Model 230/8 and 250/8

Fig. 01-22/1

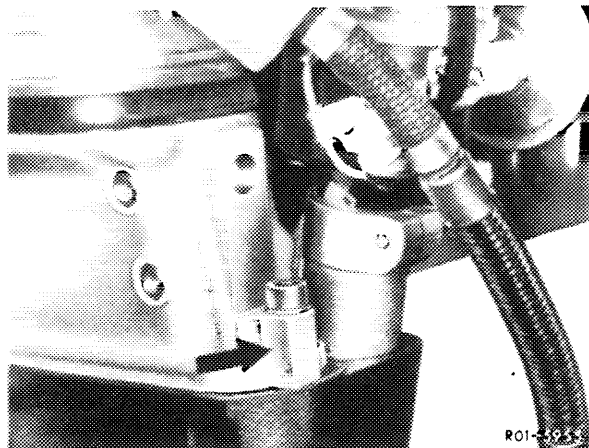
The fastening eye on cylinder head front left (refer to Fig. 01-12/1) has been increased from 16 to 23 mm and the pertinent cylinder head bolt has been extended by 5 mm (M 8 x 35).

In the event of repair jobs, make sure that for cylinder heads with fastening eye 16 mm high the cylinder head M 8 x 30 will be used, and

with fastening eye 23 mm high, cylinder head bolt M 8 x 35.
